21st November 2019

Reference: 190746.01FA

PEER REVIEW OF THE TRAFFIC AND PARKING ASSESSMENT OF THE PROPOSED MIXED USE DEVELOPMENT AT 187 - 203 PEATS FERRY ROAD

Figure 3.6: Swept paths for car park entrance/exit (B99 and B85 vehicles)

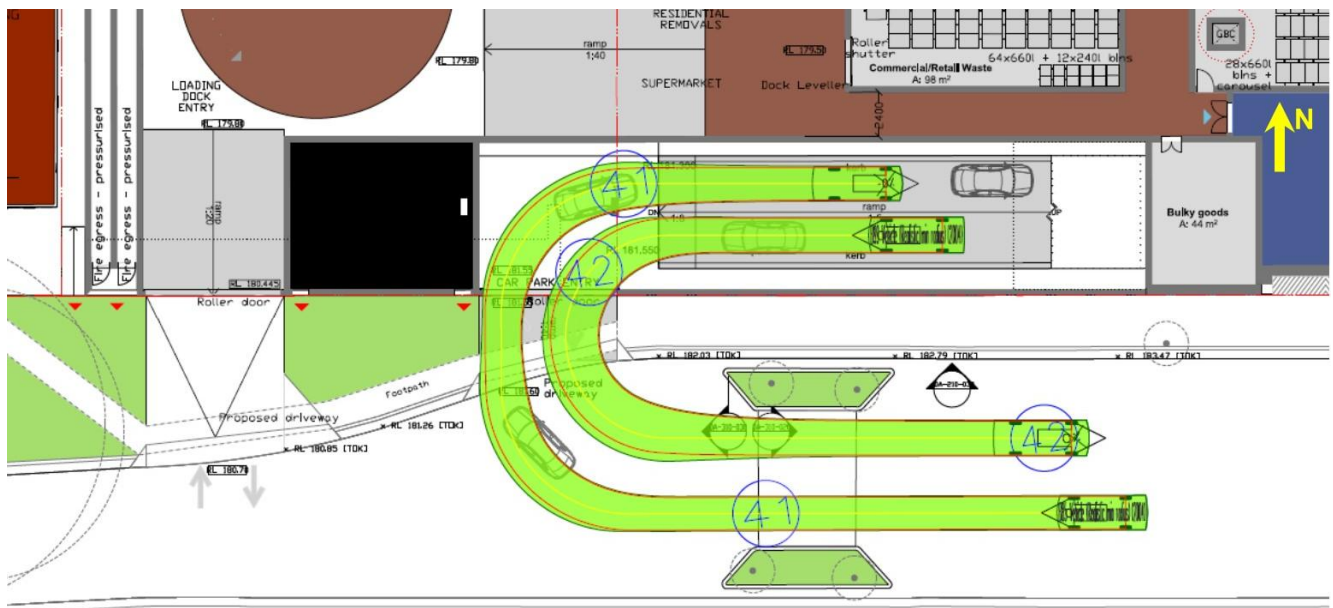
- 2.5.5 The internal swept paths of the basement car parking areas are unsuccessful with the following relevant to note:
- The entry and exit swept paths do have any vehicle clearance in accordance with AS2890.1:2004 requirements (Figure 3.6 of JTP Report);

Figure 3.8: Swept Paths for B2 (B99 and B85 vehicles)

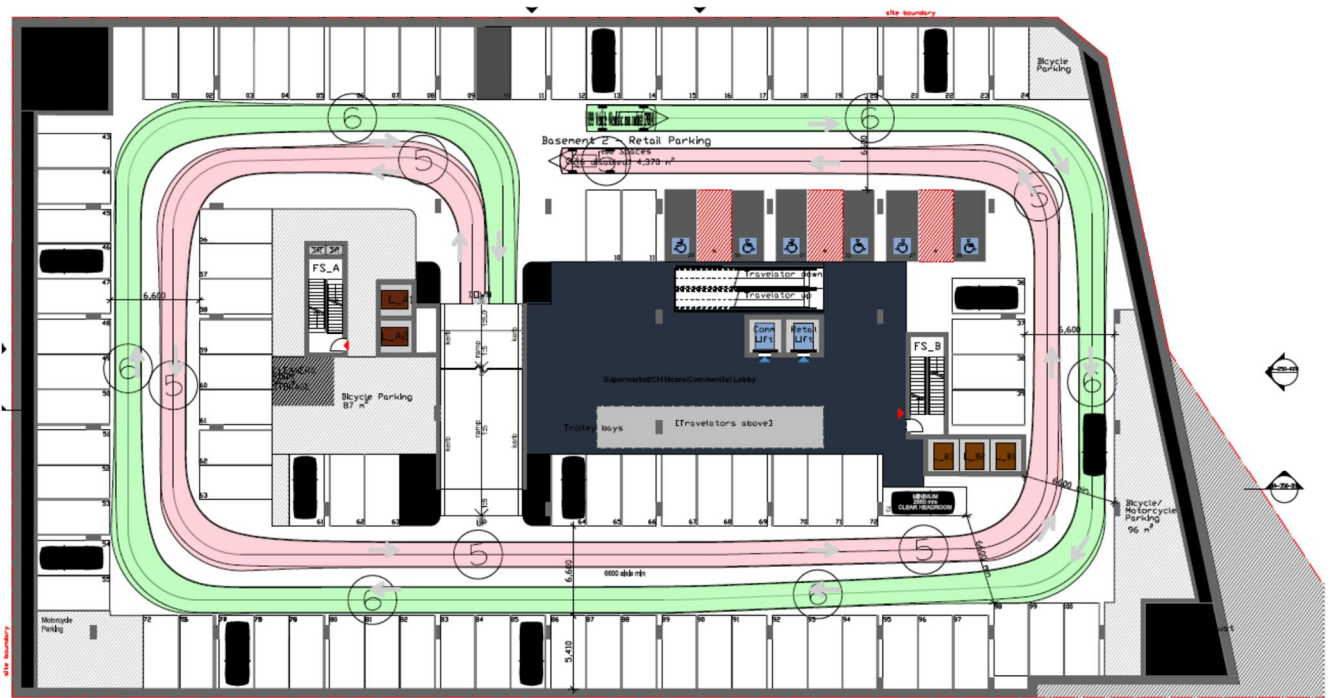
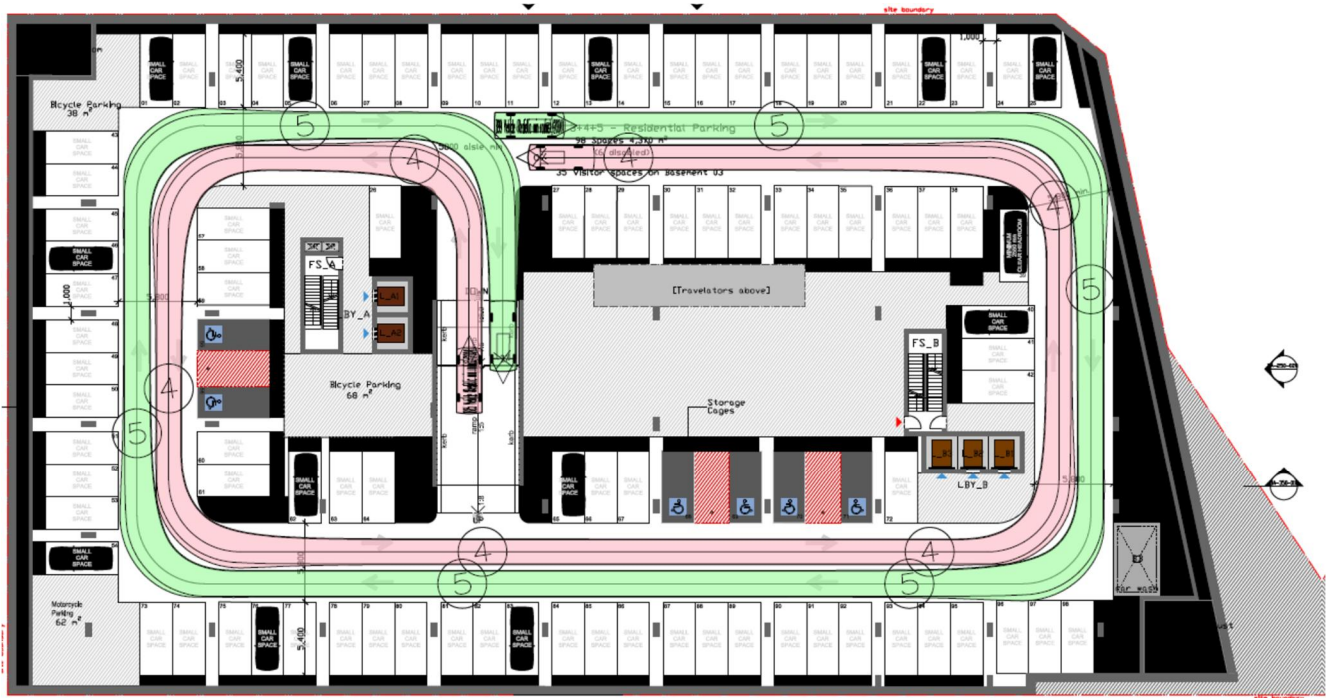
- The swept paths in Basement 1 are shown to travel over car parking spaces and have no vehicle clearances. This applies to all basement levels (Figure 3.7 to Figure 3.9);

Figure 3.11 : Left turn path from Peats Ferry Road to Dural Street

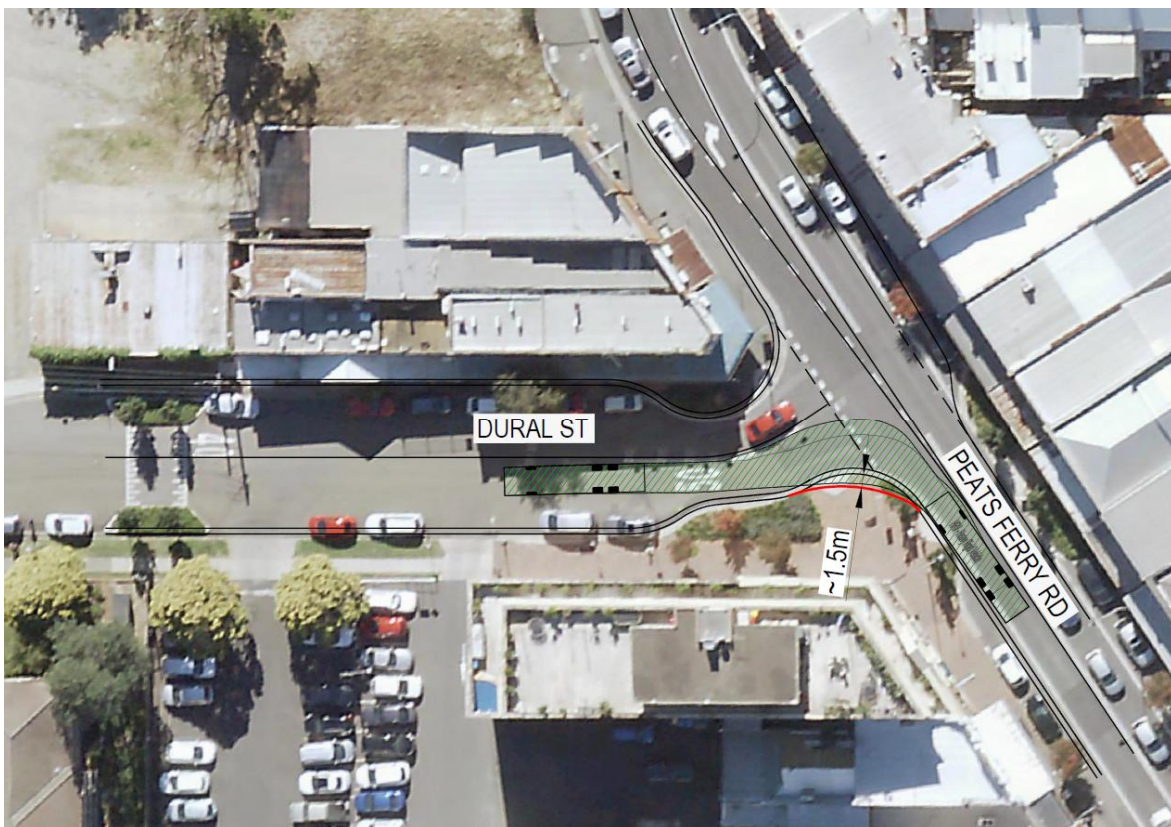
- The 12.5m length Heavy Rigid vehicle turning right into Dural Road encroaches into the parking lane along Peats Ferry Road;

- The right turning 12.5m length Heavy Rigid from Peats Ferry Road travels over the centreline of Dural Street which is unacceptable;
 - The statement that the left turning HRV into Peats Ferry Road is legal is simply incorrect. The swept paths clearly show that it is impossible for a 12.5m length Heavy Rigid Vehicle to turn left onto Peats Ferry Road;

Figure 3.14 : Left turn path between Peats Ferry Road and William Street

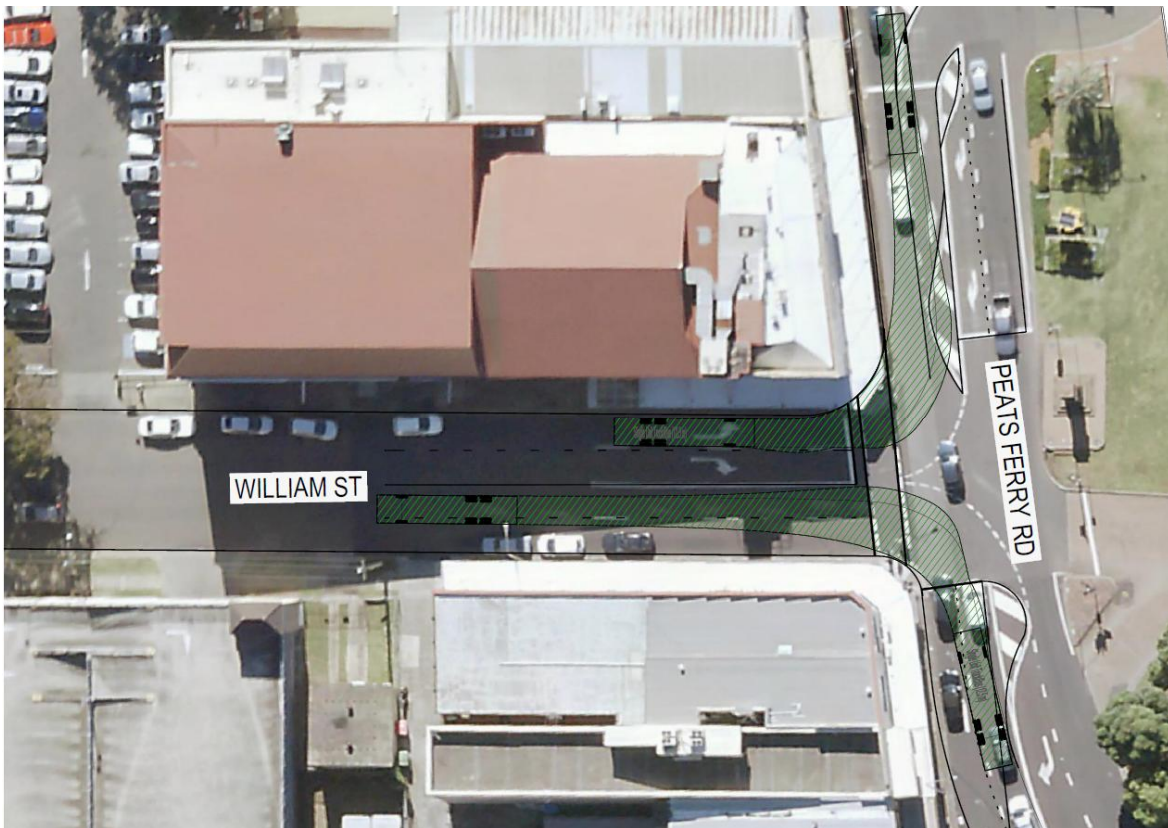
- Clearance at intersection on public roads should comply with the requirements in *Austroad Design Vehicle and Turning path Templates Guide 2013*;
 - The left turn movement from William Street onto Peats Ferry Road is not successful. The swept path clearly cuts the corner of the road;
